1 **ADDENDUM NO. 1 (Rev 1/2023)**

2 **ISSUE DATE: October 20, 2023**

3  
4 **RE: Williams Fieldhouse Seating Renovation**  
5 **University of Wisconsin, Platteville - Athletics Department**  
6 **Platteville, Wisconsin**  
7

8  
9 Division Project No. **H-22-001**

Graphic Scale	
UWSA Number	H-22-001
MSN Number	
Set Type	BD
Date Issued	09/20/2023
Sheet Number	<b>M101</b>

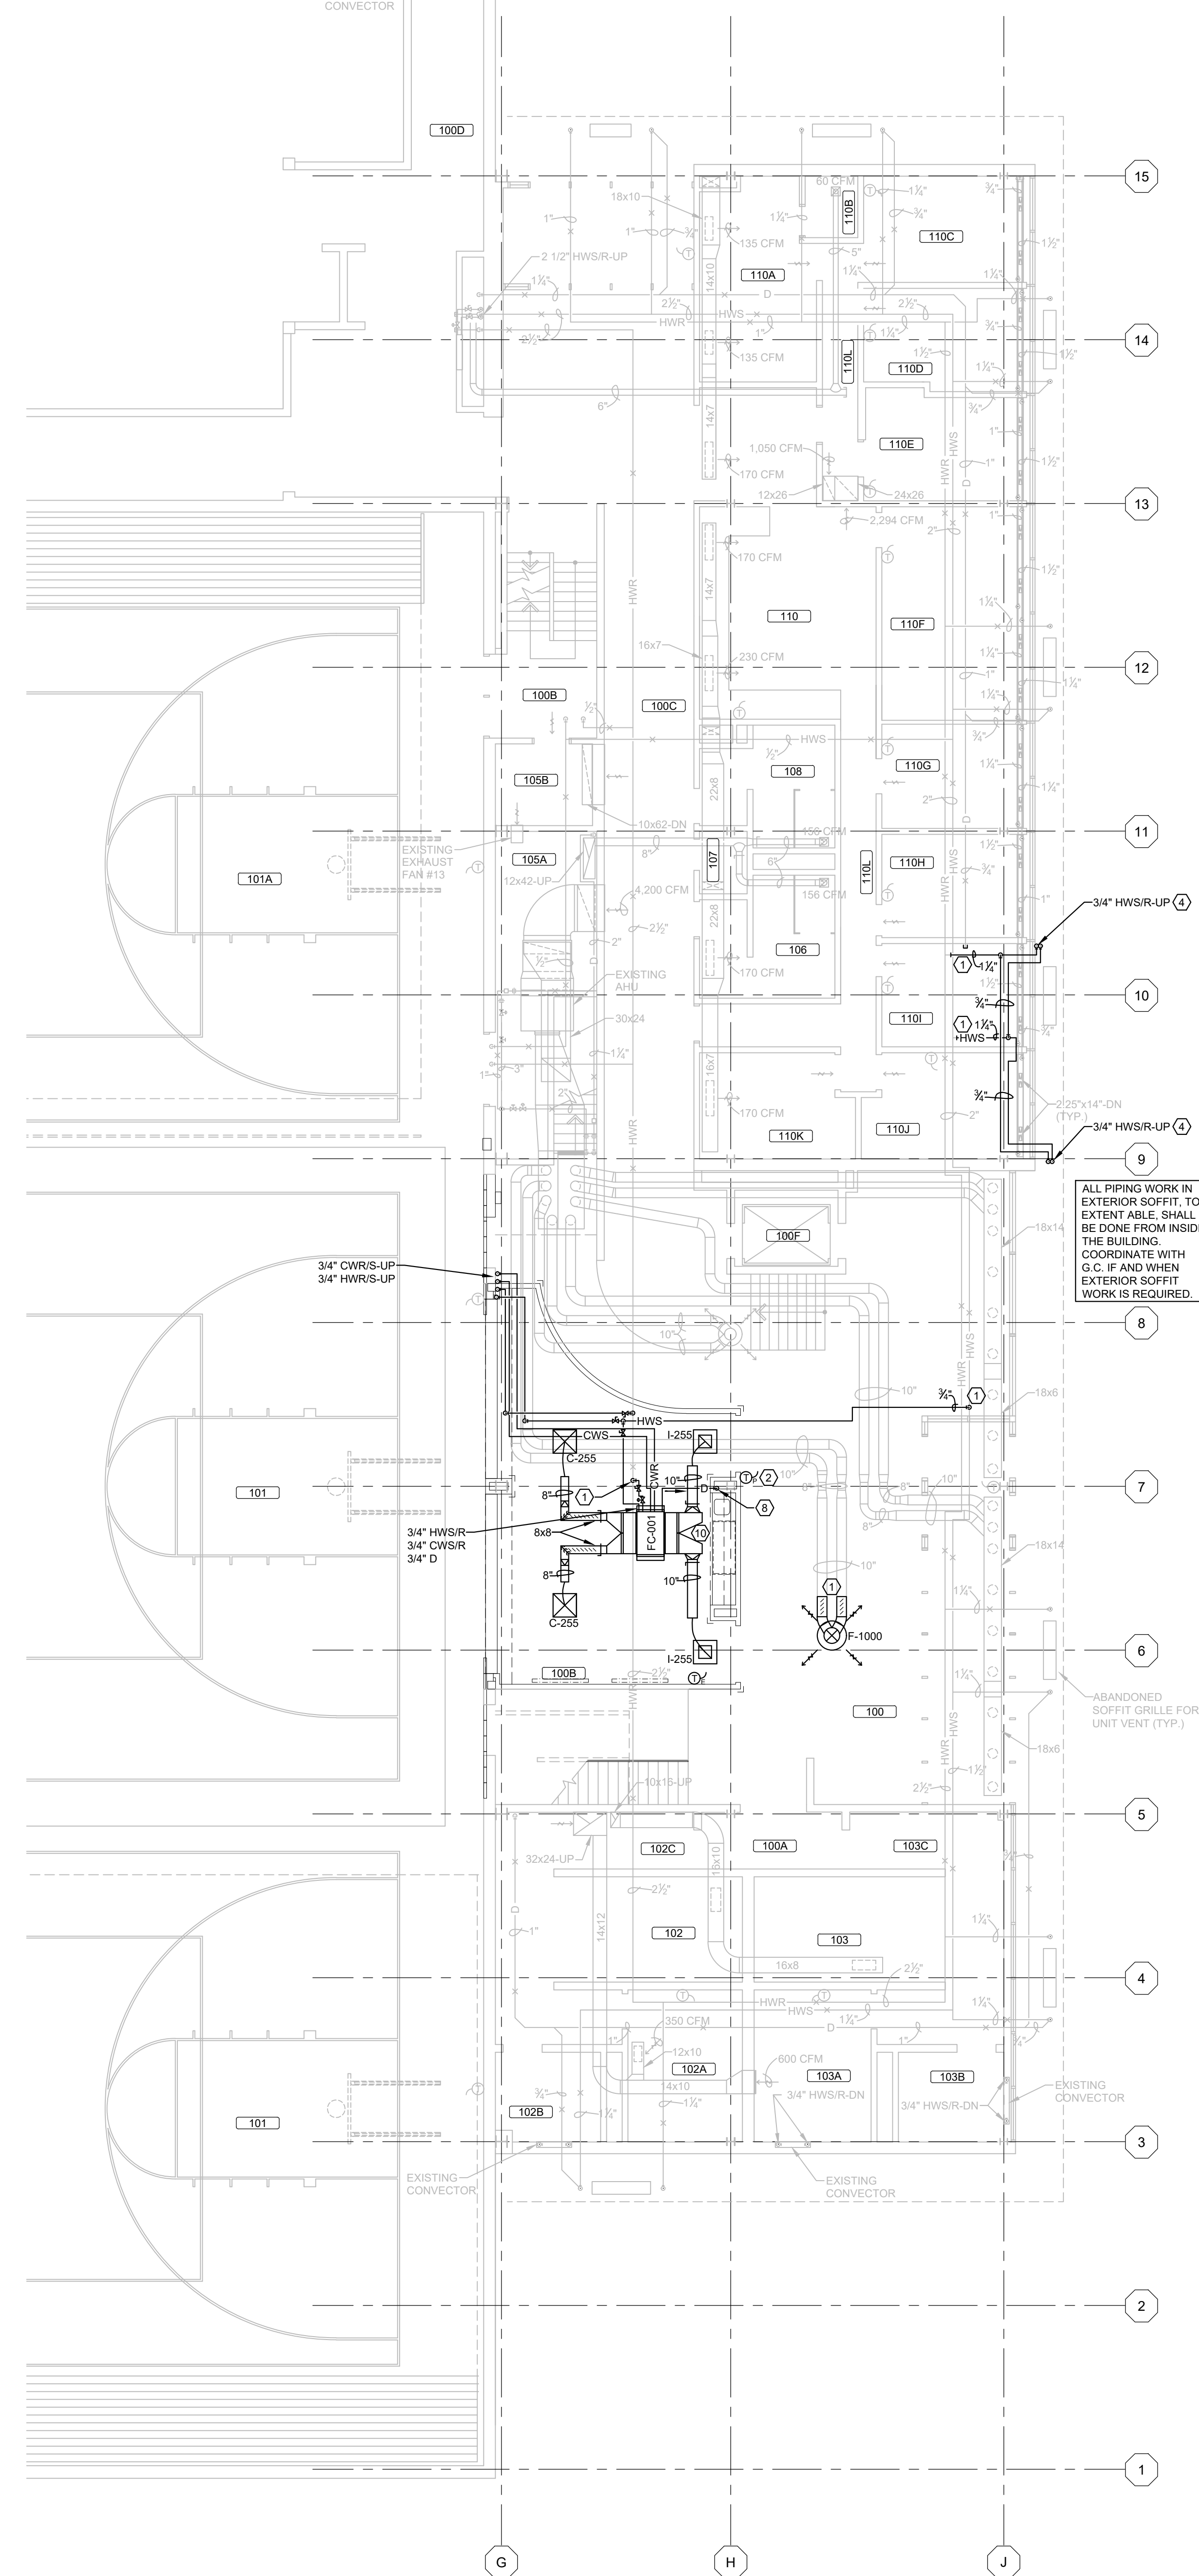
- 1 2. Drawing M101 FIRST AND SECOND FLOOR PLANS – NEW WORK  
2  
3 A. This drawing is being re-issued with this addendum.  
4  
5 1. Add second duct sensor. Duct sensor to be tied to control damper/fan for shutoff in the event  
6 that the primary duct heater fails.  
7  
8 3. Drawing ED101 FIRST AND SECOND FLOOR DEMOLITION PLANS  
9  
10 A. This drawing is being re-issued with this addendum.  
11  
12 1. All existing data cable(s) to be reused. Provide new as required per plan.  
13 2. Salvage the existing device(s) and j-box(es) on the north wall of Gym 101 as indicated.  
14 Device(s) and j-box(es) will be reinstalled. See floor plans.  
15 3. Relocate existing fire alarm strobe in Gym 101 as indicated on the floor plan.  
16  
17 4. Drawing EP101 FIRST AND SECOND FLOOR POWER-SYSTEMS PLANS  
18  
19 A. This drawing is being re-issued with this addendum.  
20  
21 1. Relocate existing fire alarm strobe in Gym 101 as indicated on the floor plan.

- 11 PROVIDE DUCT THERMOSTAT (SET TO 50F) WITH TIME DELAY RELAY (2 MINUTES MIN, 5 MAX) WIRED TO F-001 AND CD-001. IF THE FAN IS SET TO RUN AND THE DUCT TEMPERATURE DOES NOT MEET SETPOINT, THE FAN SHALL SHUT OFF AND THE CONTROL DAMPER SHALL CLOSE. TIME DELAY IS TO PREVENT NUISANCE TRIPS.  
 DUE TO AIRFLOW SWITCHES, DUCT HEATERS WILL AUTOMATICALLY SHUT OFF.

Sheet Number: **EP101**

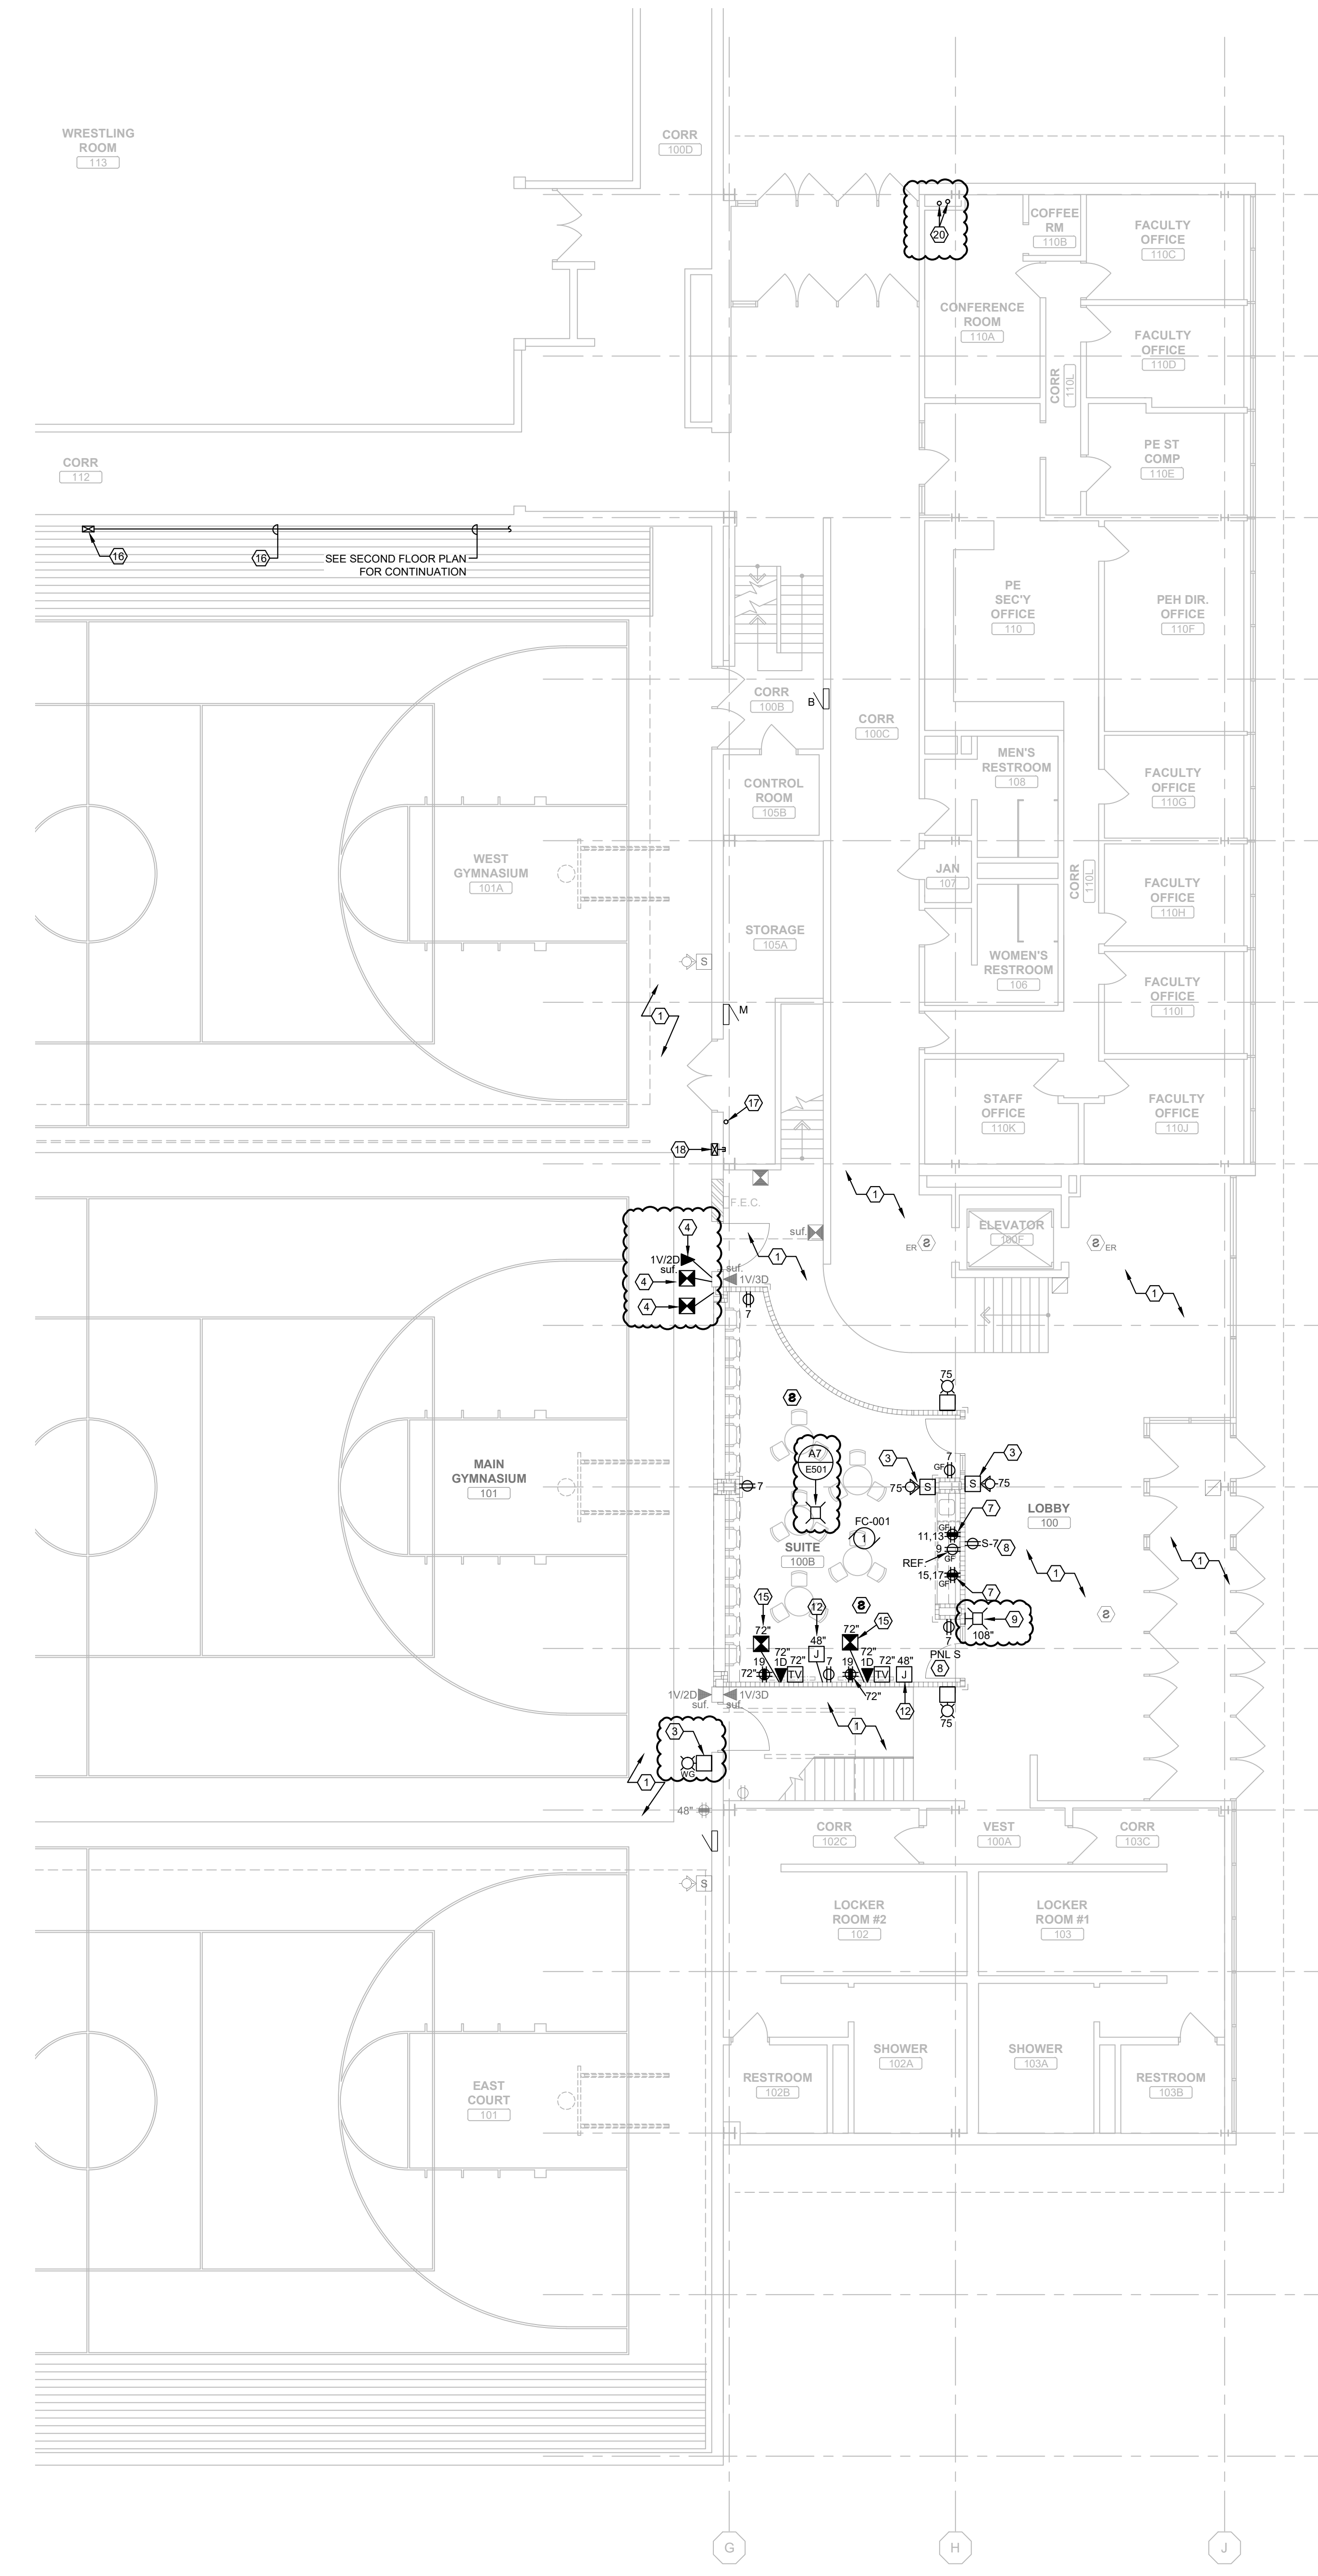
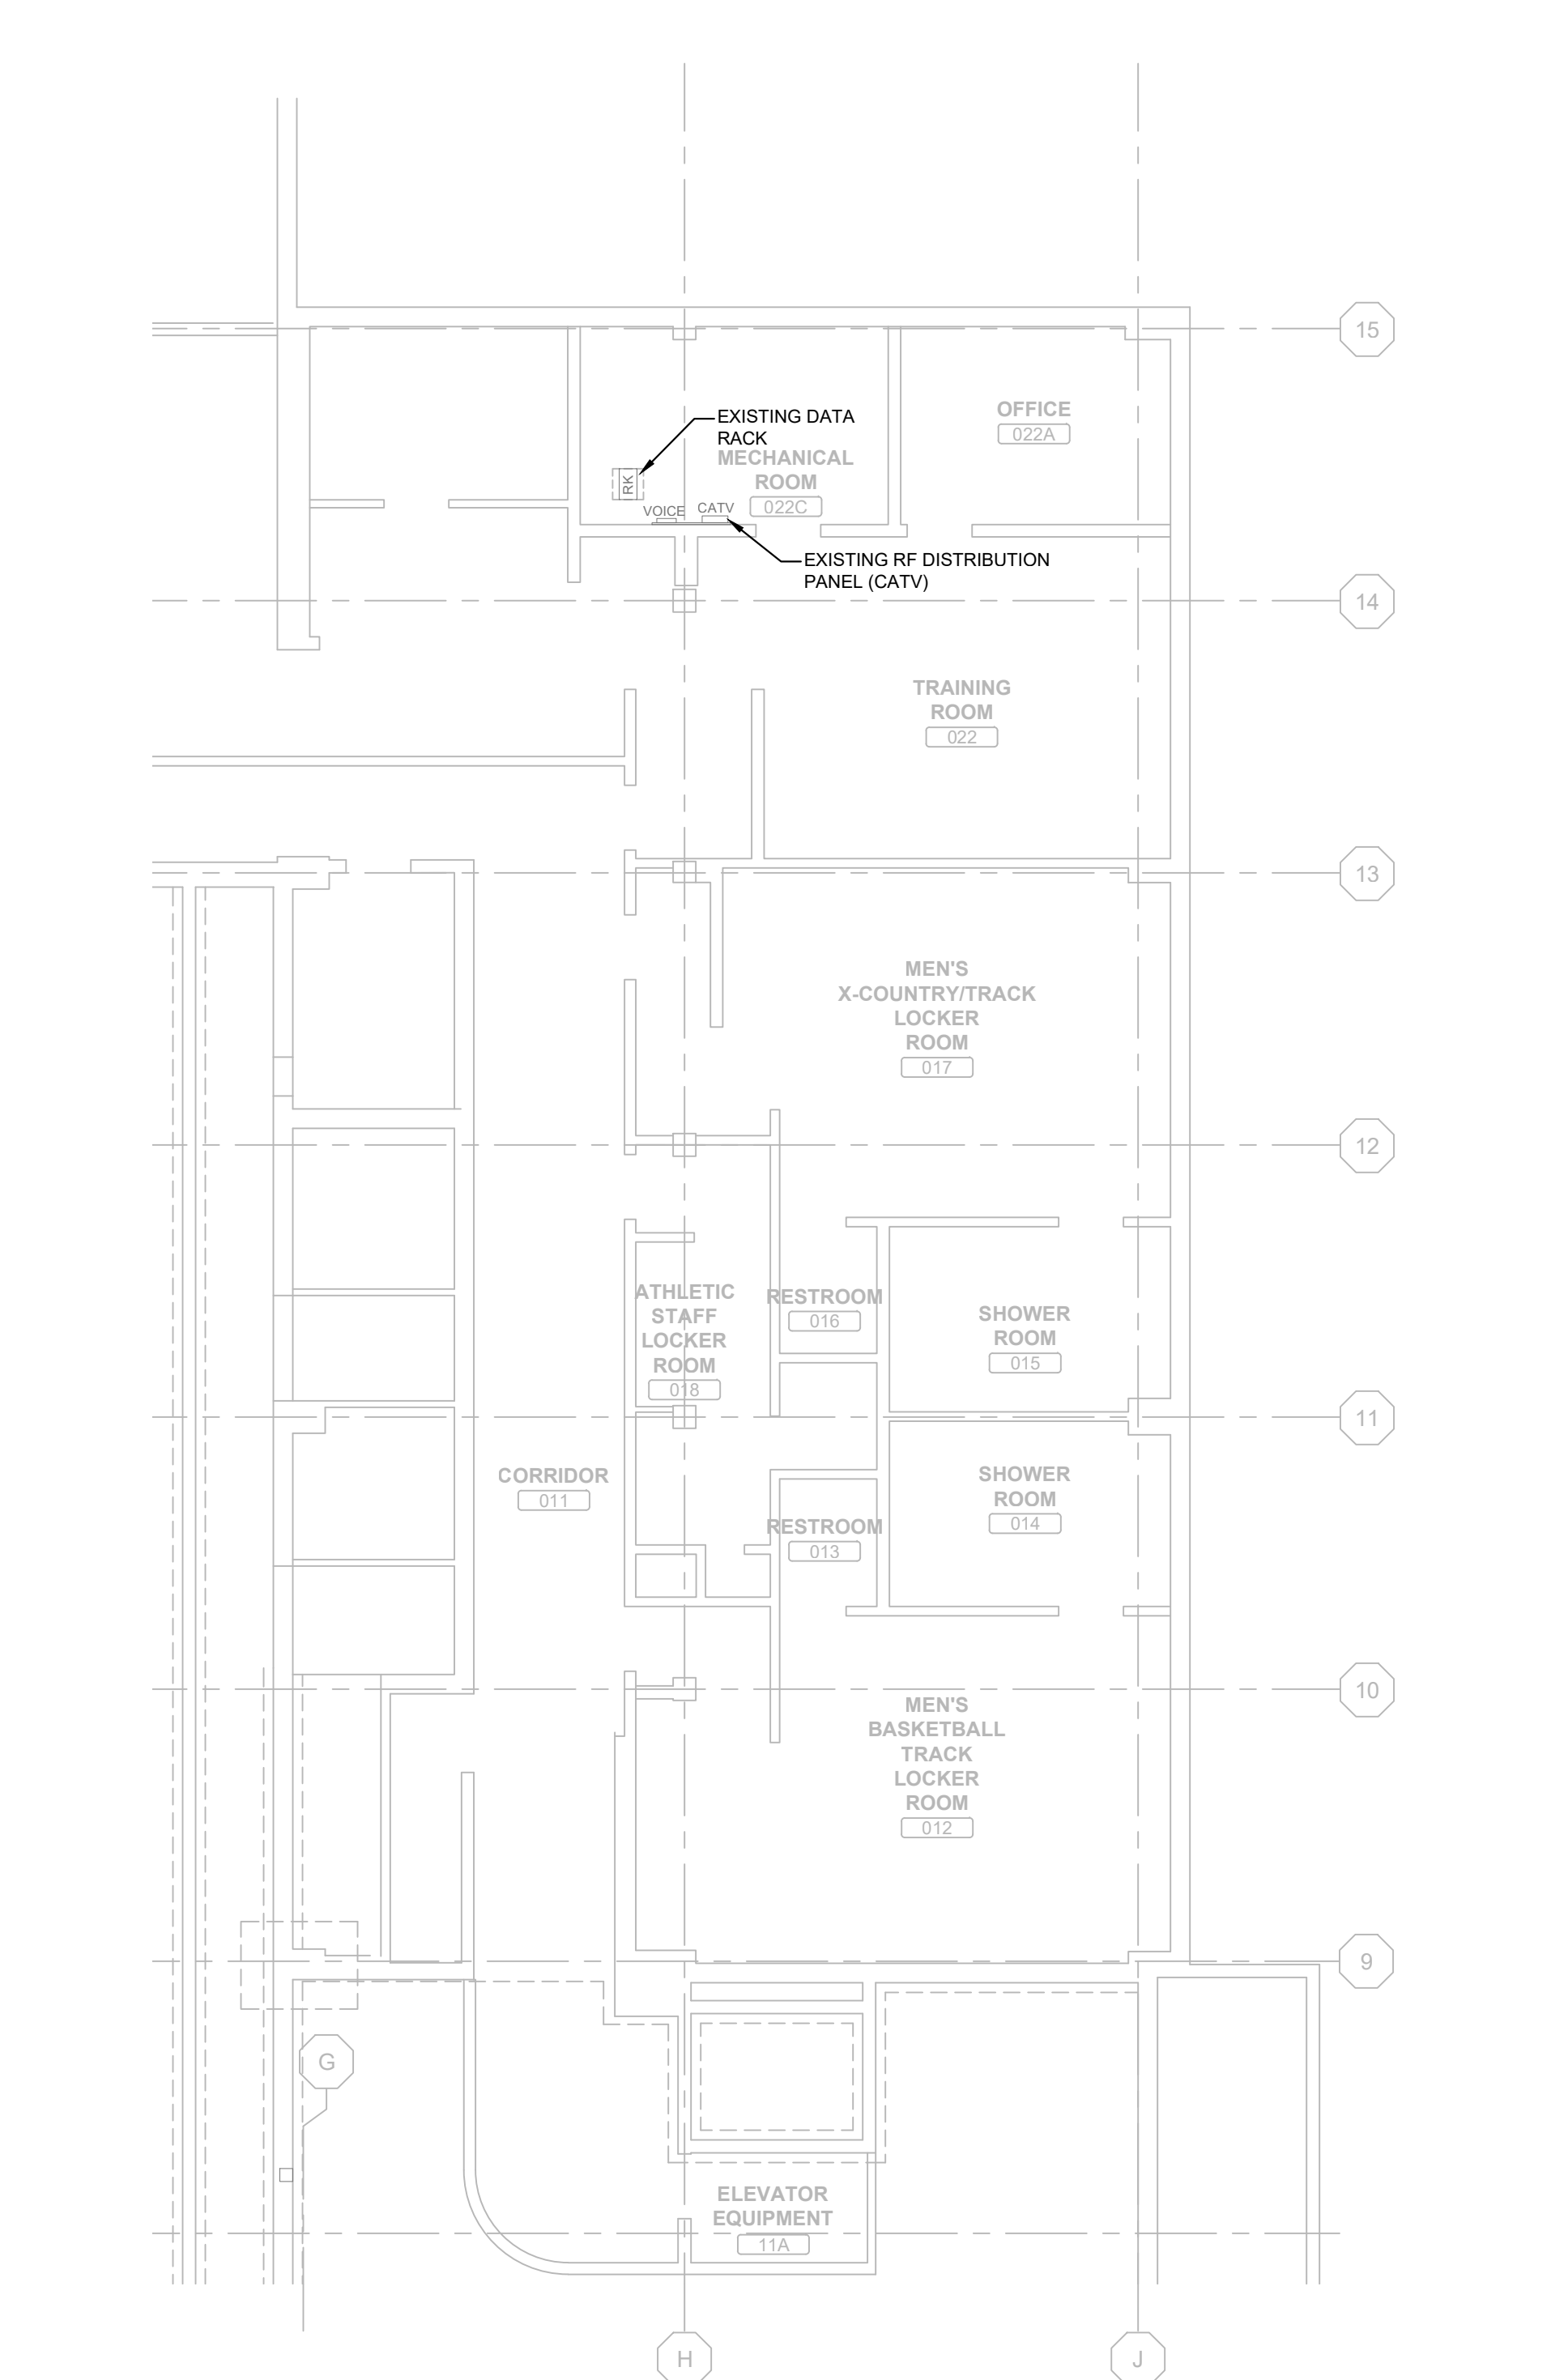
22 2. Add additional WiFi devices as indicated on the floor plans.  
23 3. Provide new conduit pathways up to first and second floors. See floor plans.  
24  
25 5. Drawing E501 SCHEDULES AND DETAILS  
26  
27 A. This drawing is being re-issued with this addendum.  
28  
29 1. Added WiFi mounting detail.  
30  
31
